TECHNICAL MEMORANDUM

Prepared by: Tom Myers, Ph.D., Hydrologic Consultant, Reno NV

Re: Review of Phase 2 Ground-Water Investigation Report for the San Mateo Creek Basin Legacy Uranium Mines Site

Figure 8: Uranium concentrations (mg/l) for groundwater in the Lower Basin alluvium. Source: EPA (2018) Figure A4-13.

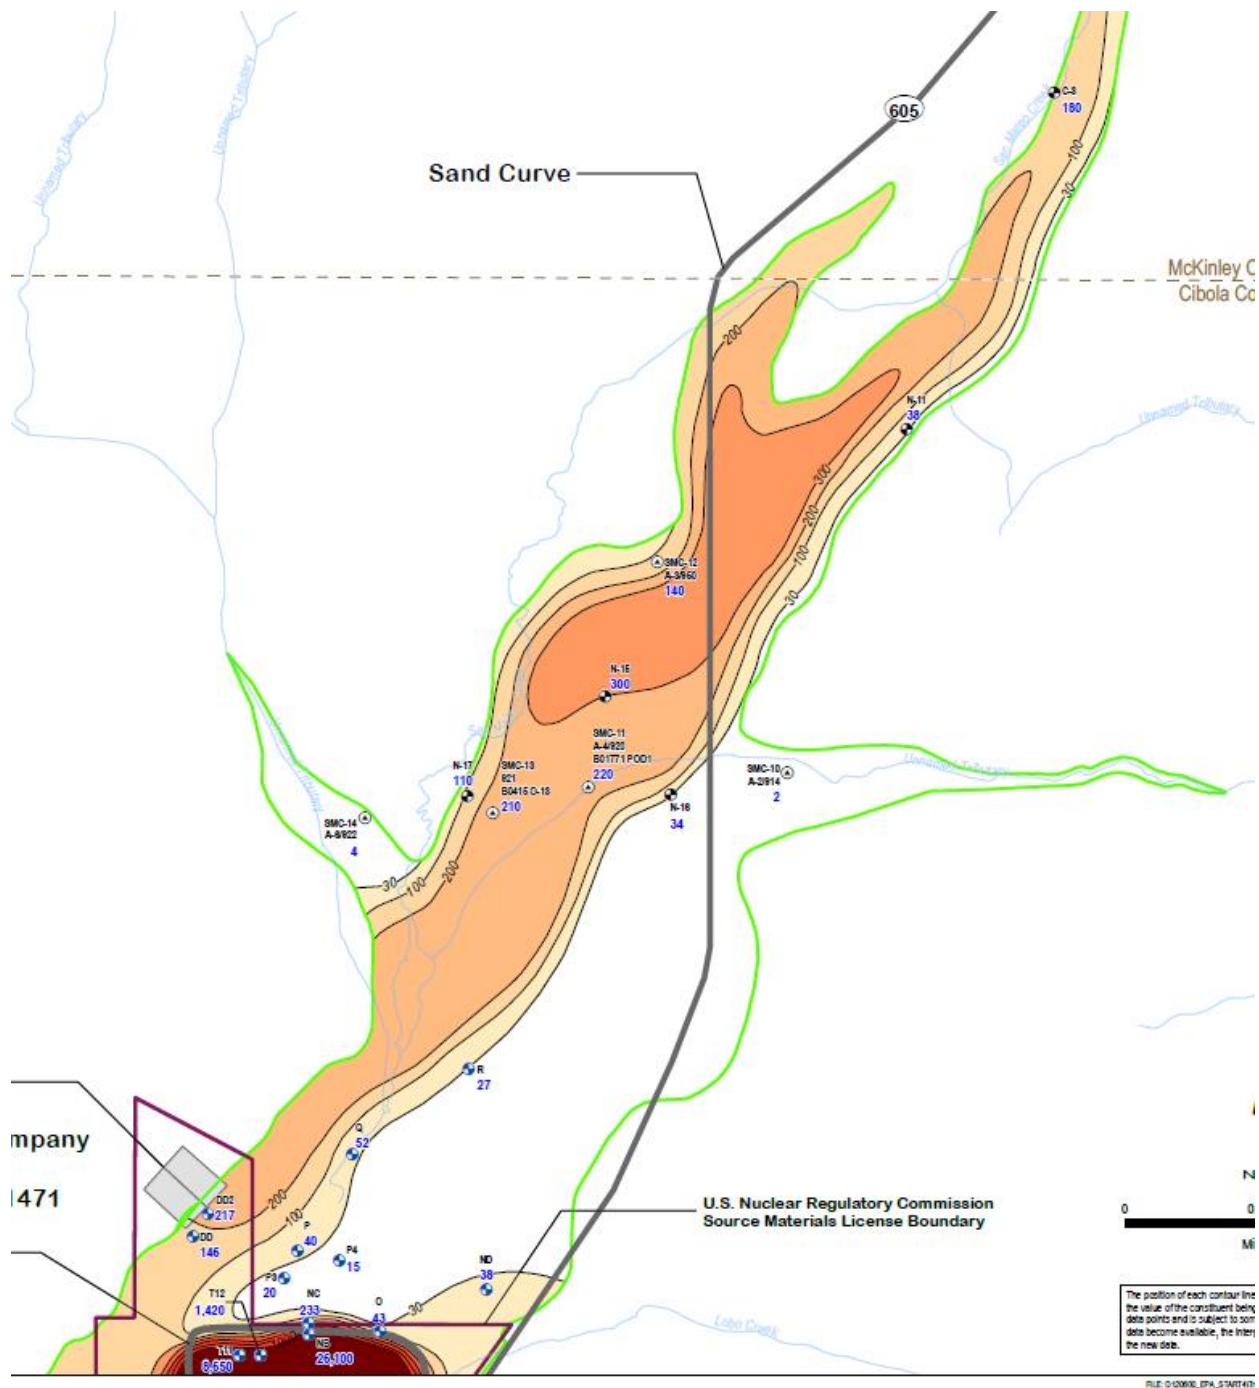
The 2015 U plume map shows the plume has spread southwestward along the paleochannel, but also that it has spread so the highest concentrations are lower than in the 1970s (Figure 8). This is reasonable, but again the data does not support the plot. There is a large area over a mile long that exceeds 300 ug/l just south of Sand Curve but only one well, M-16, with a U concentration equal to 300 ug/l (Figure 8). The extent of the 200 to 399 ug/l contour further south to well DD2 has more support with three wells exceeding 200 ug/l. The plume maps show that U from upstream moved along the San Mateo paleochannel to the LTP region through time. However, in 2015, wells just north of the LTP, P3 and P4, had very low concentrations, just 20 and 15 ug/l (Figure 8). If the 1970s observations in this area had been affected by mounding under the LTP, as suggested by Myers (2015), the 2015 data presented here suggests that more recent groundwater flows have helped to restore the groundwater to pre-millsite conditions. The report suggests there is a small inflow from the Lobo Creek drainage that is not affected by mining; this could be returning part of the groundwater to background conditions, and be representative of background in the area (p A1-40 and A5-19).

Figure 10: Tailing seepage impacts in the Milan area from the DOE Bluewater Disposal Site (Bluewater Mill) and Homestake Mining Company NPL Site. Source: EPA (2018) Figure C1-1

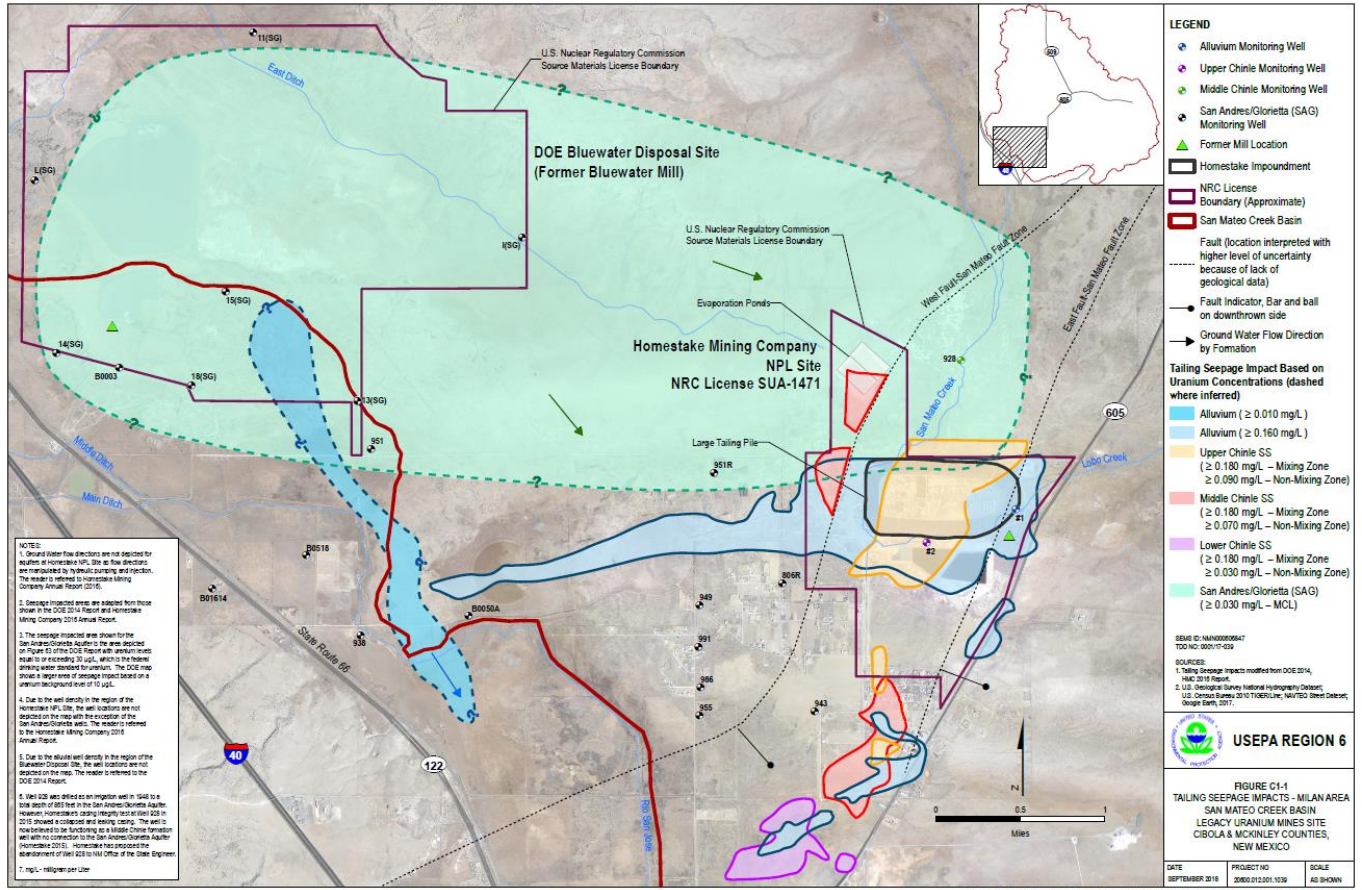
The Bluewater Mill has caused a huge plume of U-contaminated groundwater in the San Andres-Glorietta aquifer, shown as the green area in the north of Figure 10. This probably resulted from the “[s]everal billion gallons of tailing fluid [that] seeped from the bottom of the tailing impoundment and not the underlying alluvial aquifer and the Permian San Andres Limestone and Glorieta Sandstone” (p C1-4) beneath the site. The plume has moved south of east and now contaminates the SAG aquifer beneath the Homestake site (Figure 10). There is also contaminated alluvium south of the Bluewater

Mill, although Figure 10 lists the concentration as exceeding 0.010 mg/l, which is less than the standard; it is not clear why this plume is important or shown on this figure.

The LTP is the source of a U plume with concentration exceeding 0.16 mg/l that covers an area about ¾ mile north-south at the LTP about 4 miles east-west (Figure 10). The mass of high-U groundwater at the LTP is the source for high U values further south and southwest (Myers 2015). Three additional plumes of high-U concentration groundwater occur in alluvium for several miles south of the LTP (Figure 10). Although these plumes are on the general flow path, there is no obvious explanation for the variable concentrations along the flow path. There are exceedances also shown in the upper, middle, and lower Chinle formation (exceedance level shown in the figure legend) that appear to coincide with areas of high U in the overlying alluvium. The cross-section (Figure 12) shows that the alluvium is likely the source for high U in the Chinle, with a mixing zone in each.

- Why does the U plume extend several miles west of the LTP even though this direction is generally upgradient for flow in the alluvium (Figure 10)?
- What causes the highly variable U concentration in the alluvium southwest of the LTP, as evidenced by the variable high concentration areas? Does flood irrigation and other farming practice in the area contribute to the variation?
